Access Compliance Report

Public Rights-of-Way

| Intersection ID: 29736 | Main Street: BALLANTYNE CORPORATE PCross Street: HARNEY DR | Location: NW |
| ADA ID: 8471C6E39576 | Ramp Type: BlendTrans2 | Initial Pass/Fail: Pass Overall Compliance: No Severity Score: 15.25 |

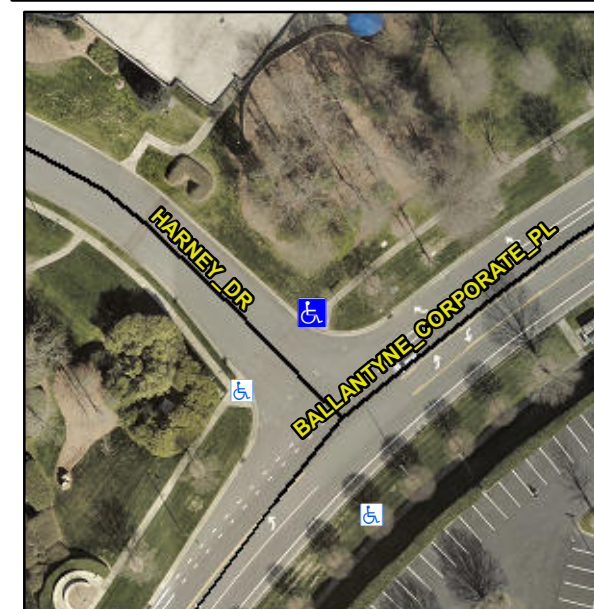
R304.5.3, R305, R304.5.4

| Compliance | Description | Data | Compliance | Description | Data |
|------------|-----------------------|--------|------------|-----------------------------|--------|
| Yes | Ramp Width (in) | 48.0 | No | BlendTrans XSlope (%) | 3.2 |
| N/A | Landing Length (in) | N/A | No | DWS Provided? | No |
| Yes | Gutter Ponding? | No | No | Gutter Slope (%) | 5.8 |

Remove & Replace Curb Ramp With Two New Directional Ramps or Equivalent. Remove & Replace Gutter.
